Errata for 2018 Uniform Plumbing Code – 6th Printing

Appendix I – IAPMO IS 31

FIGURE 3
PRESSURE LOSS OF PEX TUBING AT 16 °C (60°F)
(See Section 10.6.2)

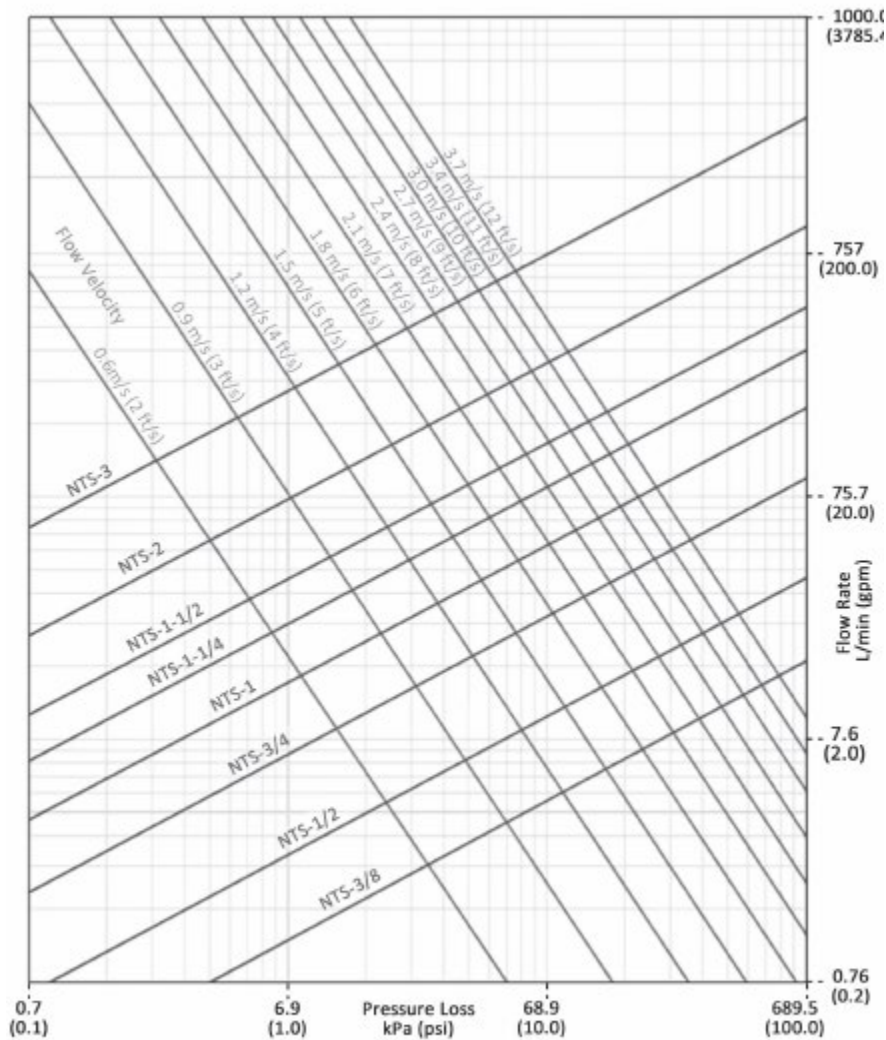
Figure 3 – Revise the conversion under 689.5 at the bottom of the figure, from “(10.0)” to “(100.0)”.

FIGURE 4
PRESSURE LOSS OF PEX TUBING AT 49 °C (120°F)
 (See Section 10.6.2)

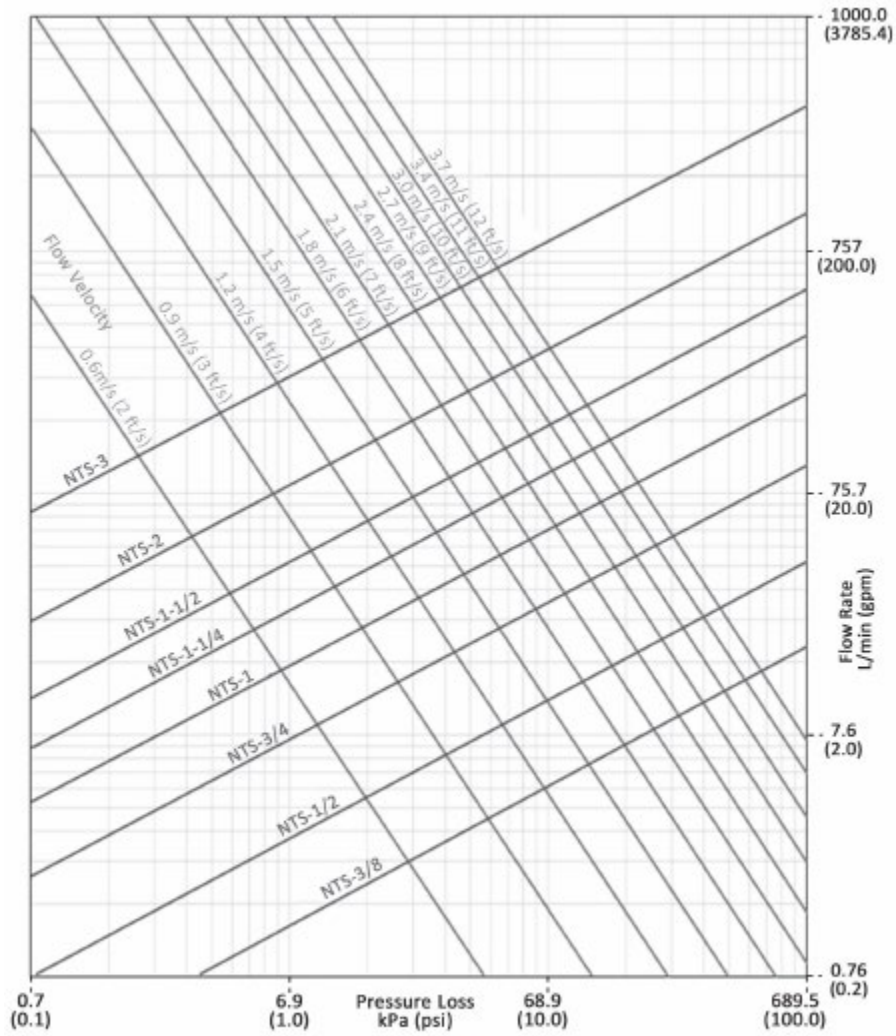
Figure 4 – Revise the conversion under 689.5 at the bottom of the figure, from “(10.0)” to “(100.0)”.
